SIB 51 16 22

**TAILGATE SPOILER CONTACTS THE ROOF TRIM WHEN OPENING**

E-Series	Model Description	Production Date
I20	iX Sports Activity Vehicle	Up to August 31, 2022

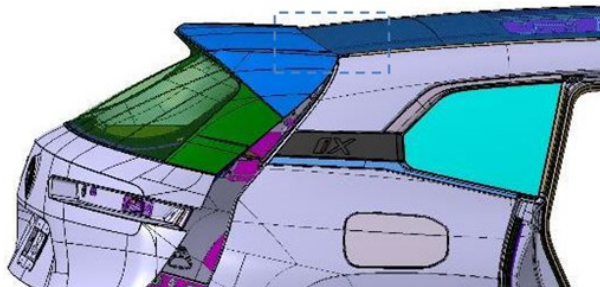
The tailgate spoiler contacts the roof trim while opening (Rear driver's side view shown).

The roof trim and tailgate's spoiler expand when the outside temperature is warm. This can cause rear spoiler to contact the roof trim.
